## **SERIES 60® 2007 Service Information**

**NUMBER:** 08 60-7   **S.M. REF.:** 8.5   **ENGINE:** EPA07 Series 60   **DATE:** November 2008

**SUBJECT: EGR RATE MEASUREMENT SYSTEM**

**PUBLICATION: DDC-SVC-MAN-0005**

**Figure 1 Removal of Straight Tube and Flange Assembly**

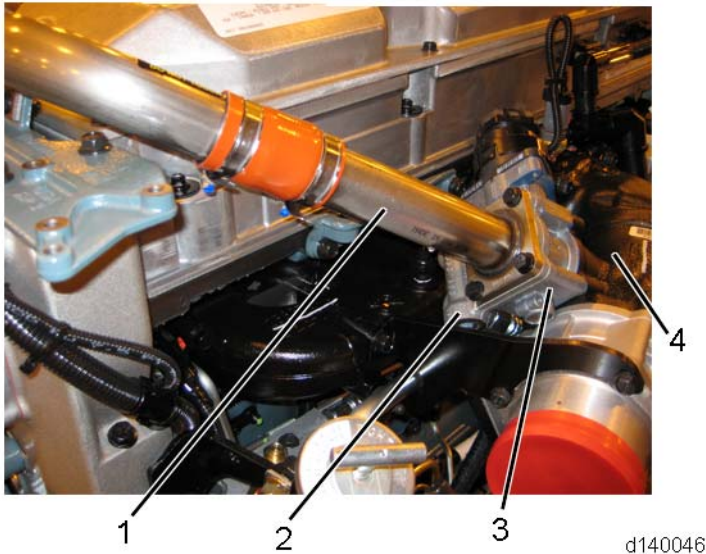
The EGR Rate Measurement system provides DDEC with measurements resulting in EGR flow rate prediction. The EGR Delta Pressure Sensor and its associated hardware such as venturi, etc. have been removed from the EPA07 Series 60 engine effective with engine serial number 06R0999679 built on March 13th, 2008. Updated fuel maps that turn the sensor off are being used to calculate EGR flow rates instead of using the sensor. A straight tube and flange assembly replaced the venturi.

<b>NOTICE:</b>
The EGR Delta Pressure Sensor and its associated hardware such as venturi, etc. have been removed from the EPA07 Series 60 engine effective with engine serial number 06R0999679 built on March 13th, 2008. Updated fuel maps that turn the sensor off are being used to calculate EGR flow rates instead of using the sensor. A straight tube and flange assembly replaced the venturi. For removal and installation procedures; refer to section "Removal of Straight Tube and Flange Assembly."

2. Loosen the clamps on the EGR delivery pipe hose and straight tube. Push the delivery pipe hose upward onto the delivery pipe.
3. Remove the four bolts from the EGR straight tube and flange (1).
4. Remove the straight tube and flange assembly (1) from the engine, remove the O-ring and discard.
5. Remove the EGR Valve (3) and EGR heater (if equipped) (2) from the engine; remove the O-ring and discard.
6. Slide the EGR delivery pipe hose off the delivery pipe.

**Figure 2 Tube and Flange EGR Valve Inlet Pipe, Heater Plate (If equipped), and EGR Valve Installation**

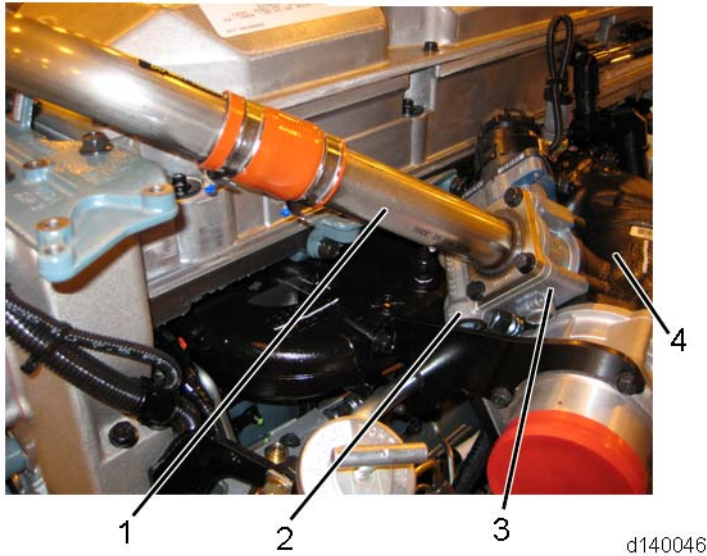
3. Position the EGR valve onto the mixer housing with two new O-ring seals. If equipped, position the EGR heater plate assembly with new O-ring seal between the EGR valve and new tube and flange EGR valve inlet pipe. Using four bolts, attach the tube and flange EGR valve inlet pipe, EGR valve heater plate (if equipped) and EGR valve to mixer housing. Torque four bolts in an X pattern to 30-38 N·m (22-28 lb·ft). Reconnect the Engine Harness to the EGR valve. See Figure 2.
